Architect's Supplemental Instructions

Architect's ASI No: 043

Project:
Webster University
Interdisciplinary Science
Building

Date Issued: 12/20/2016

M0502

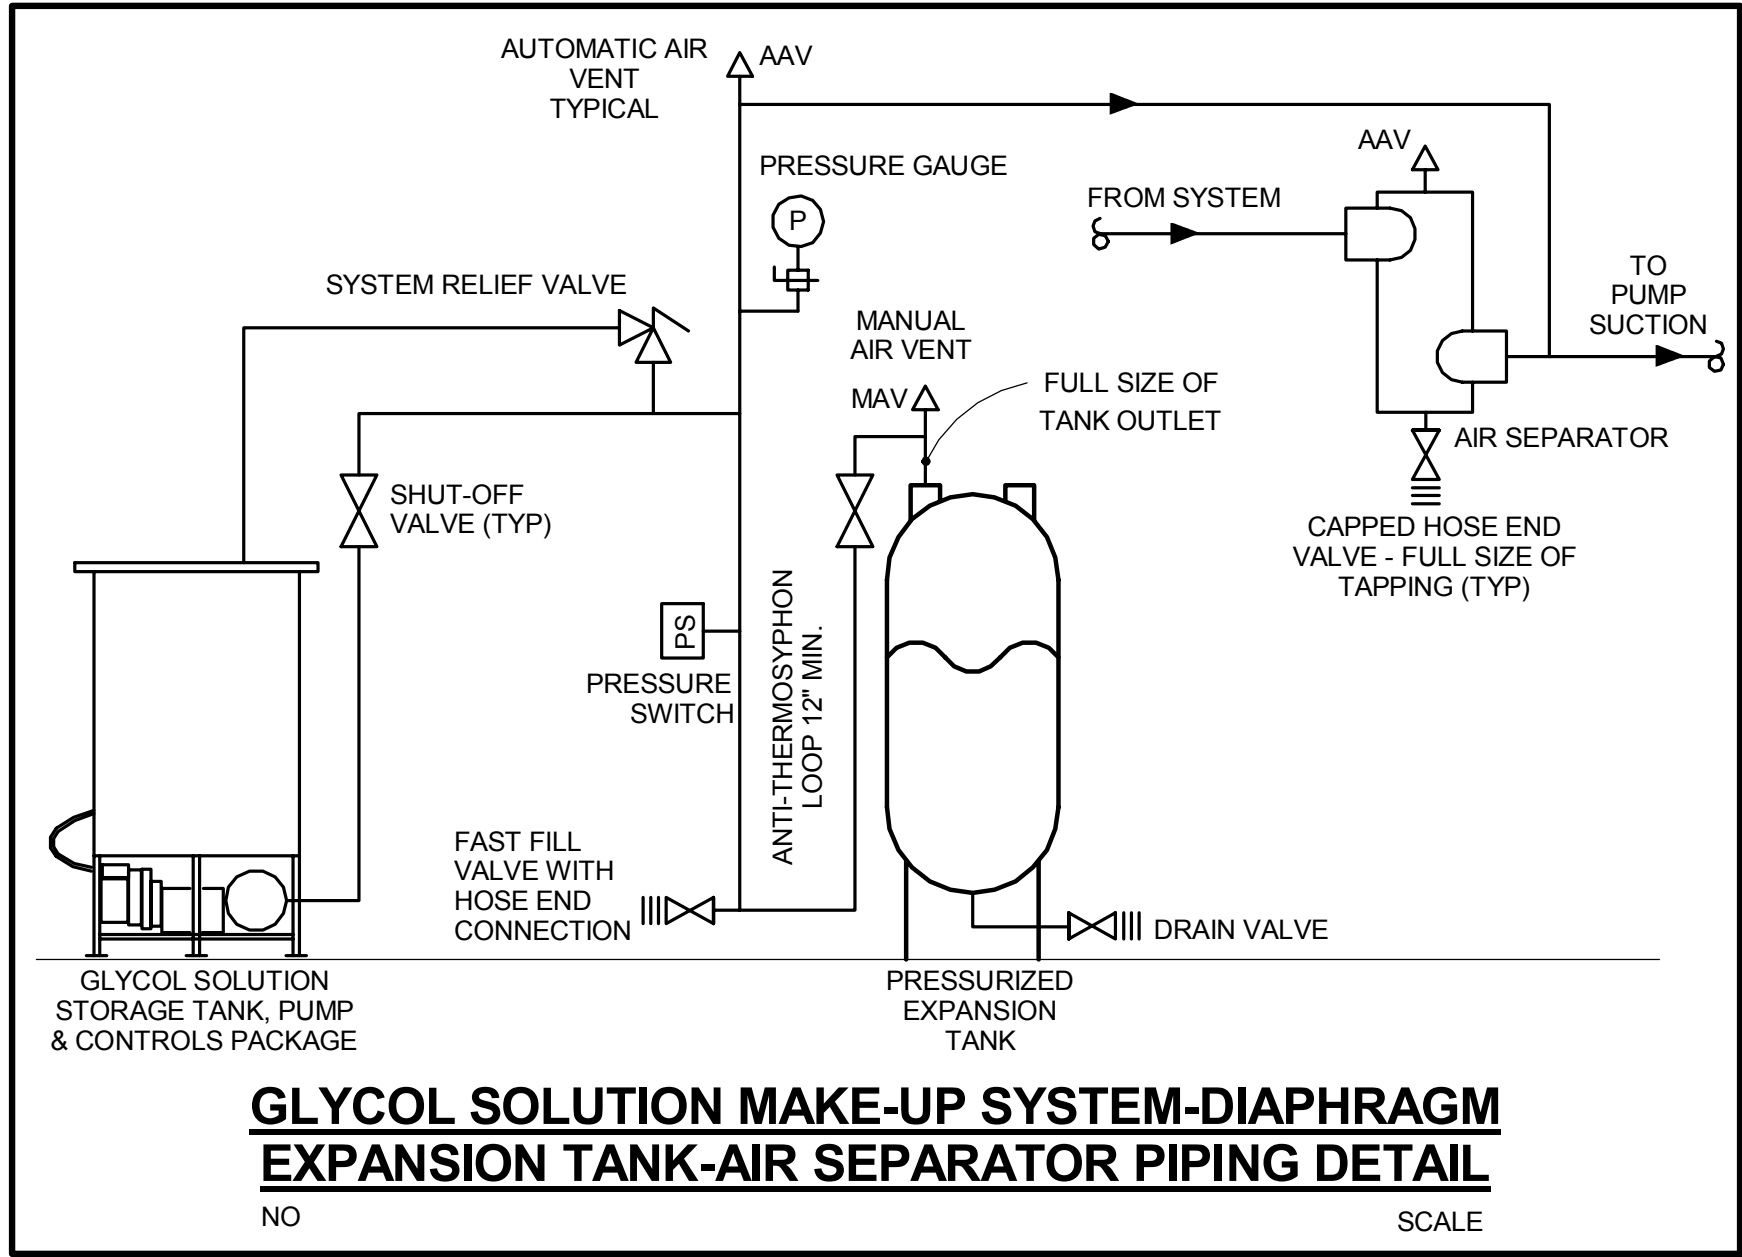
- Add H.W. TERMINAL BOX REHEAT PIPING (WITH 3-WAY VALVE) DETAIL
